**PZ&B Staff Combination Memorandum: Landmarks Preservation Commission and Town Council**

**SUBJECT:** ZON-24-0055 (COA-24-0022) 120-132 N COUNTY RD—  
Palm Beach Synagogue

**MEETING:** DECEMBER 18, 2024, LPC  
JANUARY 15, 2025, TC

**ZON-24-0055 (COA-24-0022) 120-132 N COUNTY RD—PALM BEACH SYNAGOGUE (COMBO)—SPECIAL EXCEPTIONS WITH SITE PLAN REVIEW AND VARIANCES.**

PREVIOUSLY PROPOSED COURTYARD PERSPECTIVE

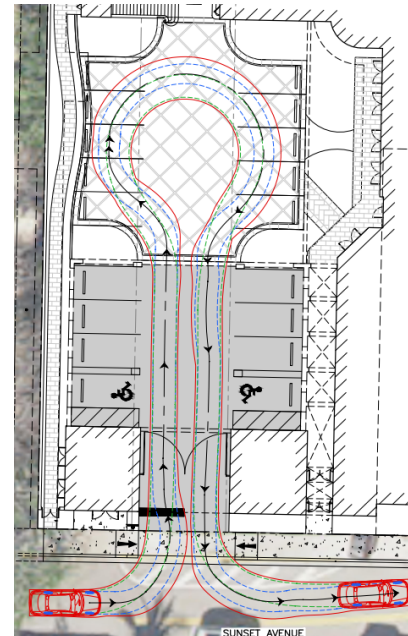
Architecturally, the building's south elevation (Sunset Ave) has not changed. However, the proposed building reduction will impact how the property is experienced internally. The changes to the new addition will not negatively impact the landmarked portions of the building. Furthermore, the architecturally compatible design and use of materials are maintained in the revised proposal.

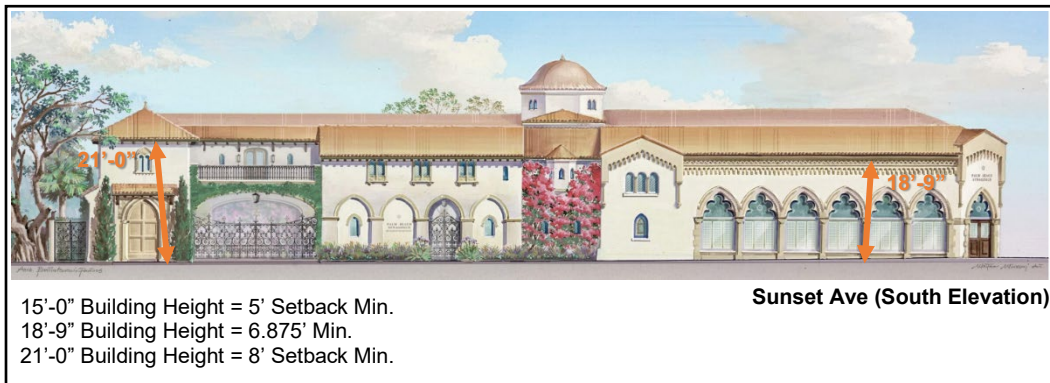
**Special Exception #1** is for a building height of 2-stories in the C-TS zoning district. The existing landmarked building has two-story portions. The property to the west (Trevini building) is a two-story commercial building. The property to the northeast contains a three-story landmarked building (Paramount Theatre). The building to the south is a two-story commercial building, while the building to the north is a one-story commercial building. Two-story buildings are the urban makeup of the immediate area and would not be out of character with the immediate neighborhood.

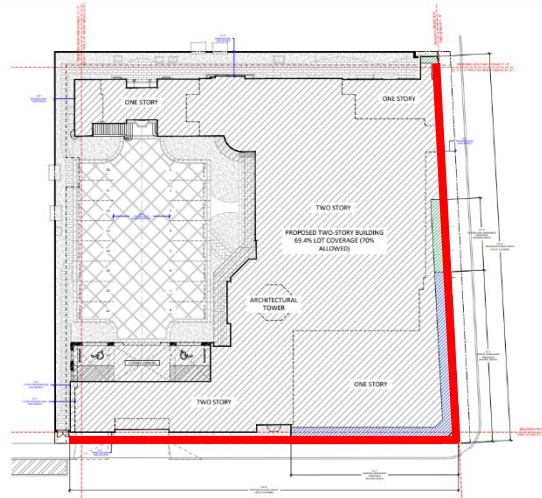
**Variance #4** requests to exceed the maximum building length of 150'-0" maximum building length permitted; the request pertains to both sides (east and south) for the proposal of alterations and substantial additions of the corner building of N County Road and Sunset Ave. Along N County Road, the existing landmarked synagogue building has a 76'-2" long frontage plus an additional 32'-2" of non-landmarked portion of the synagogue. The other structures (formerly occupied by Chez Jean-Pierre Bistro) has a 63'-8" long frontage. This structure was approved to be demolished and is proposed to be replaced by an attached new addition. The variance along the east (N County Road) is to exceed the allowance by 22'-0" for a total frontage of 172'-0". This will extend the building nearly the entire linear length (174') of the eastern side of the site which will provide for a continuous urban edge, an optimal urban condition along commercial main streets. For visual reference, the landmarked portion of the proposal is highlighted in blue in the diagram to the right.

As the variance request pertains to the building along the Sunset Ave frontage. The existing building has a building length of 74'-7" and the new additions will extend this by 87'-5" to a total length of 173'-0" along the south (Sunset Ave) of the site. And while this portion of the variance is not a vesting of the existing conditions, it too, creates a continuous architectural edge to the site and will screen the parking in the rear of the site. This elevation will be broken into two portions, by a 7'-0" wide pedestrian accessway that has been provided at the westernmost portion of the site and at the ground floor by a 25'-0" wide covered vehicular driveway also located at the western portion of the site. Overall, the new construction along both elevations of the building have been exceedingly designed to vary in detail, style, features, and changes in plane.

**North Elevation**

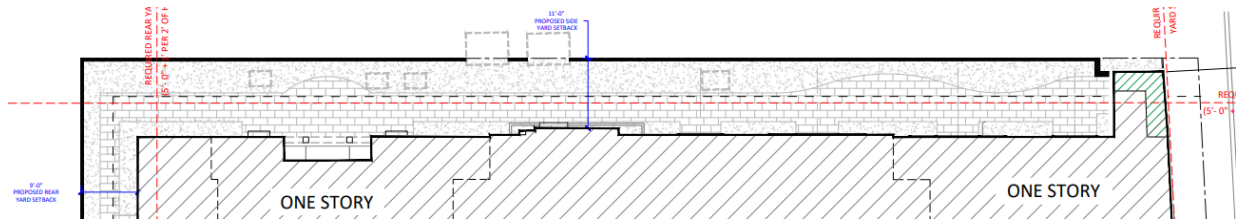
As it pertains to **Variances #8** and **#9** to the reduced setback requirement along the two frontages. **Variance #8** to reduce the minimum required side yard (north) setback from 1.8’ in lieu of the

required setback of 8'. A portion of the non-landmarked façade on the northeast corner will be preserved. However, due to the overall demolition of the building greater than 50%, the existing setback of 1.8' in this area must be retested. The additions will provide a setback of 11 feet on the north side of the property. Since portions of the addition, exceed a height of 15 feet, an increased from the minimum 5-foot setback is required of one foot for each two feet of building height. Therefore, the variance will only impact the preserved section of the building. Based on building heights, the required setback ranges from 7' to 8'.

**15'-0" Building Height = 5' Setback Min.**  
**19'-0" Building Height = 7' Min.**  
**21'-0" Building Height = 8' Setback Min**

**West Elevation**

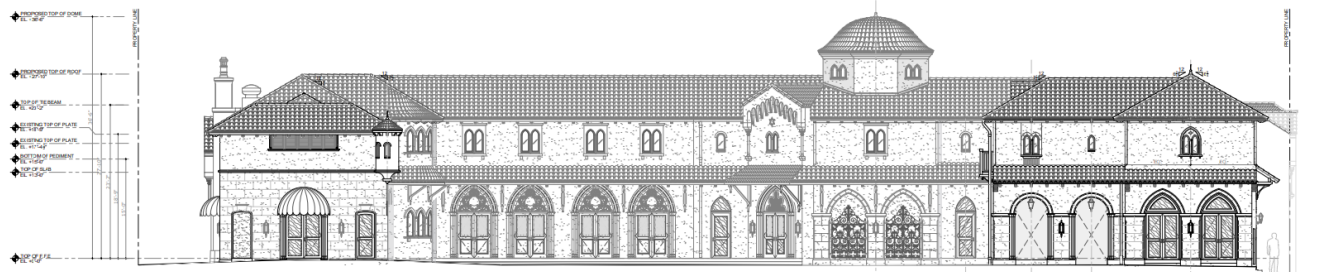
**Variance #9** to reduce the minimum required rear yard (west) setback ranging from 7' in lieu of the required setback of 13'. The additions will provide a setback that ranges from 7' to 9'. An increased setback above 15 feet of height also applies to the rear setback areas, however, the minimum setback here is 10 feet. Based on building heights, the required setback ranges from 12.166' to 13'.

**15'-0" Building Height = 10' Setback Min.**  
**19'-0" Building Height = 12' Min.**  
**19'-4" Building Height = 12.166' Min.**  
**21'-0" Building Height = 13' Setback Min.**

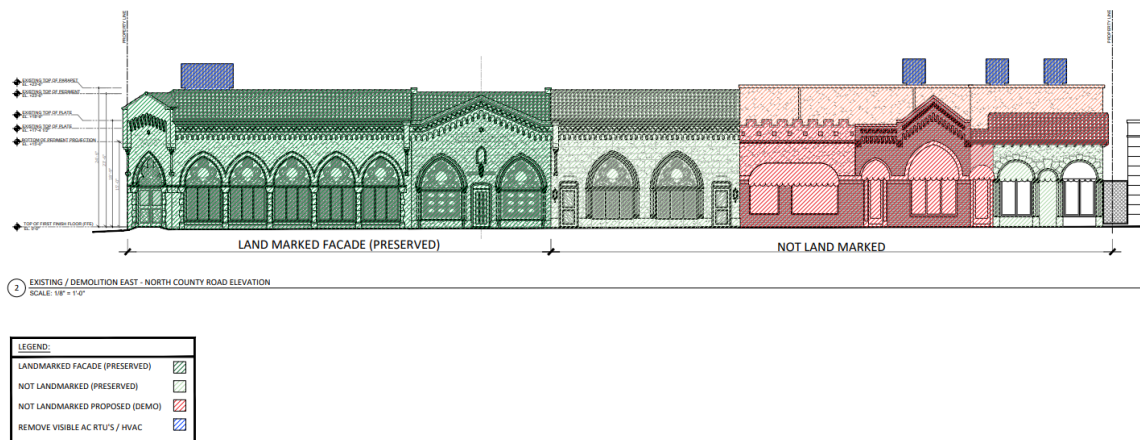
As outlined in the historic portion of this memorandum, only two (120 and 122 North County Road) of the five Kitchell buildings were landmarked, and only specific thresholds of their facades were protected. These buildings are significant historic resources in the Town of Palm Beach with a prominent location at the northwest corner of North County Road and Sunset Avenue. The proposal preserves the landmarked facades and portions of non-landmarked facades at 124-126, and 132 N County Rd. The proposal respects the landmark's architecture with articulation that sets the additions back on Sunset Avenue and steps back the majority of the second floor from the first-floor massing along North County Road. The fenestration pattern is well thought out. The additions utilize architectural features and materials in a manner that is complimentary to the existing synagogue as well as Palm Beach in general. Once again, from a design standpoint this proposal is a success.
